ALERT SERVICE BULLETIN

427-21-45

MODEL AFFECTED: 427

SUBJECT: MAIN ROTOR PITCH LINK ASSEMBLY 406-010-413-125/-141, INSPECTION AND APPLICATION OF TORQUE SEAL LACQUER.

**Figure 1 – Torque Seal Lacquer (C-049) Application
(Model 407 Pitch Link Assembly Shown as an Example)**

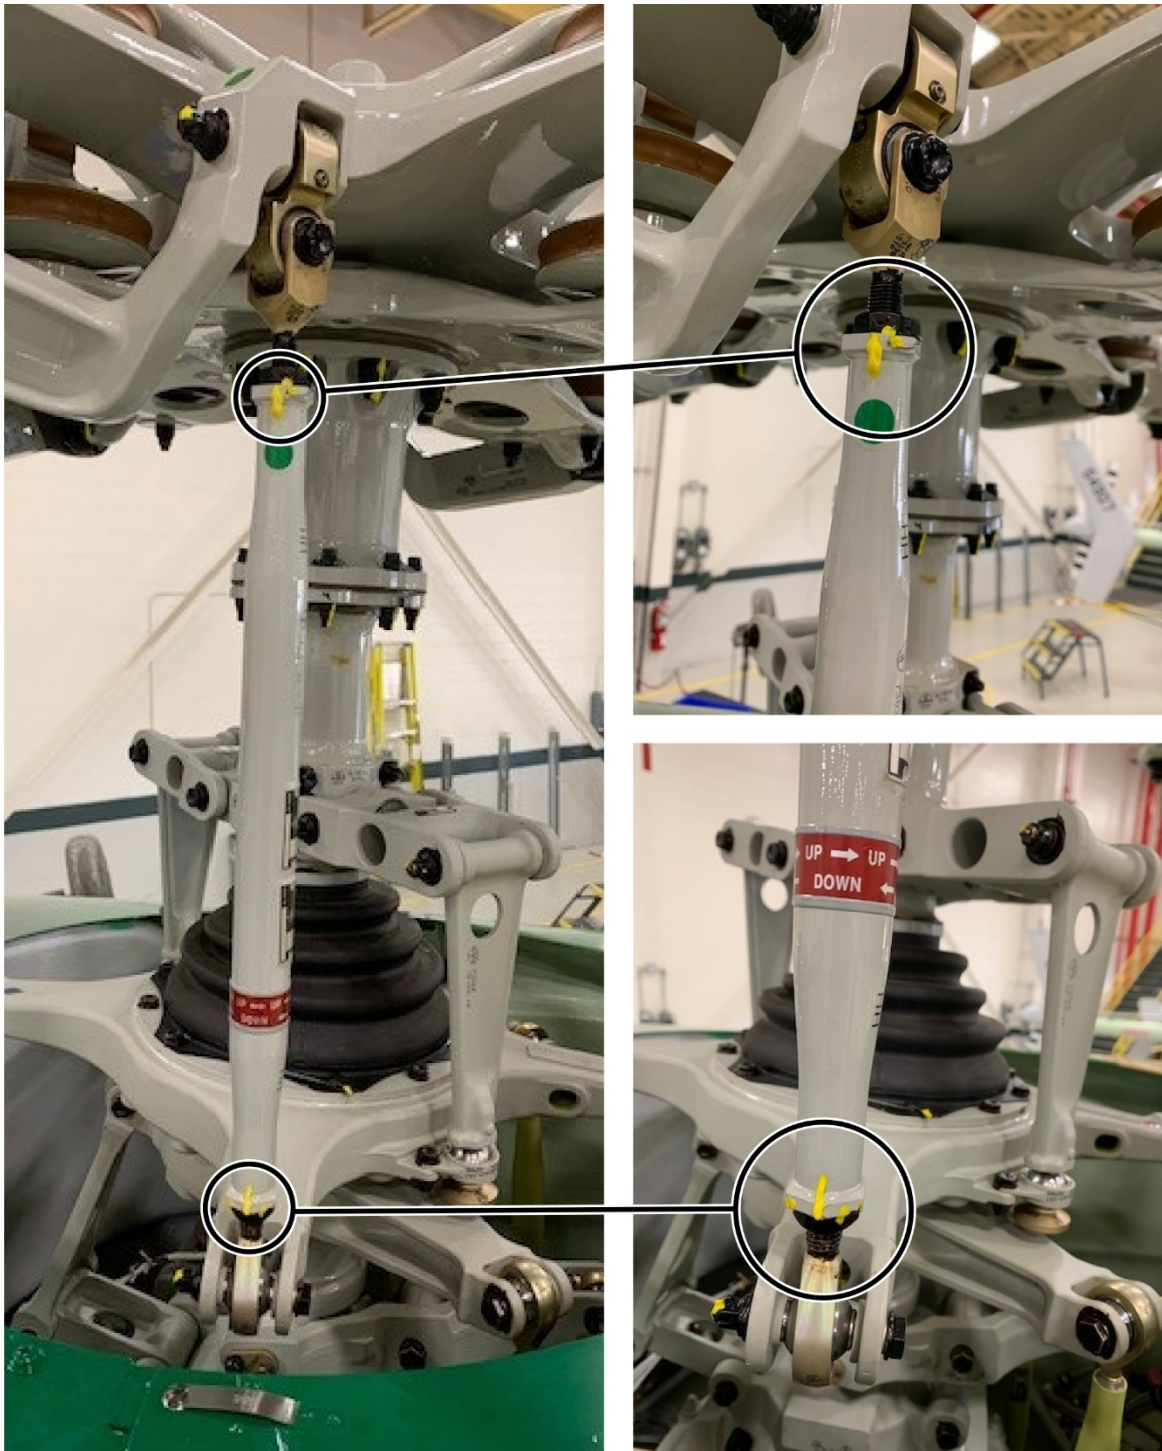
- (2) If the insert is not debonded, re-apply torque seal lacquer (C-049), or equivalent, as shown (Figure 1).
 - (3) If the insert is found debonded, or suspected to be, go to step 2.c.
